# Access Compliance Report

## Public Rights-of-Way

### (Curb Ramps)

Intersection ID: 7128	Main Street: DALECREST_DR	Cross Street: KENMONT_DR	Location:	W
ADA ID: FAA96E6220D9	Ramp Type: Perp	Initial Pass/Fail: Fail	Overall Compliance: No	Severity Score: 8.75
Codes/Mitigation Info/Possible Solution		Field Measurements/Component Compliance

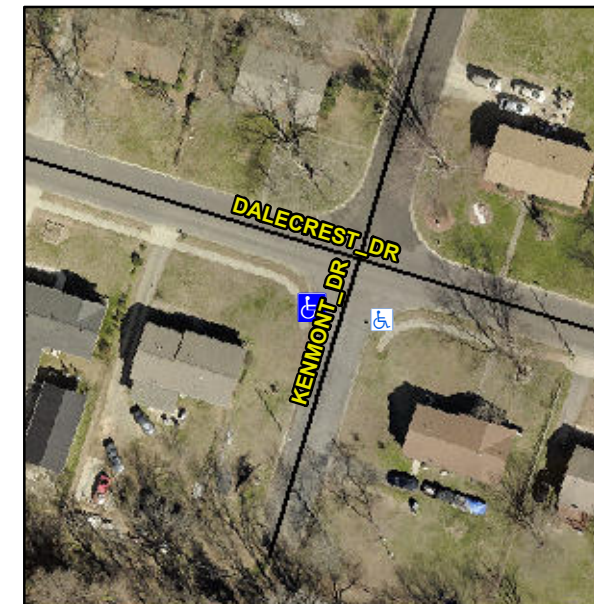
**Not Found, R304.5.1**

Compliance	Description	Data	Compliance	Description	Data
N/A	Ramp Length (in)	47.5	Yes	Ramp Slope (%)	8.3
No	Ramp Width (in)	37.5	Yes	Ramp XSlope (%)	1.2
N/A	Flare Type LT	N/A	N/A	Flare Type RT	N/A
N/A	Flare Slope LT (%)	N/A	N/A	Flare Slope RT (%)	N/A
N/A	Flare Traversable LT?	N/A	N/A	Flare Traversable RT?	N/A
N/A	Landing Length (in)	N/A	N/A	DWS Provided?	N/A
N/A	Landing Width (in)	N/A	N/A	DWS Contrast?	N/A
N/A	Landing Slope (%)	N/A	N/A	DWS Length (in)	N/A
N/A	Landing X Slope (%)	N/A	N/A	DWS Full Width?	N/A
N/A	Landing Curb? (Y/N)	N/A	N/A	DWS Offset (in)	N/A
N/A	Shared Landing?	N/A			
N/A	Gutter Ponding?	N/A	N/A	Gutter Slope (%)	N/A
N/A	Gutter Lip Ht (in)	N/A	N/A	Gutter X Slope (%)	N/A
N/A	Painted X Walk1?	No	N/A	Painted X Walk2?	N/A
	X Walk 1 Direction	To SE		X Walk 2 Direction	N/A
N/A	X Walk 1 Width (in)	N/A	N/A	X Walk 2 Width (in)	N/A
	X Walk 1 Slope (%)	3.2		X Walk 2 Slope (%)	N/A
	X Walk 1 X Slope (%)	2.1		X Walk 2 X Slope (%)	N/A

**Remove & Replace Entire Ramp.**
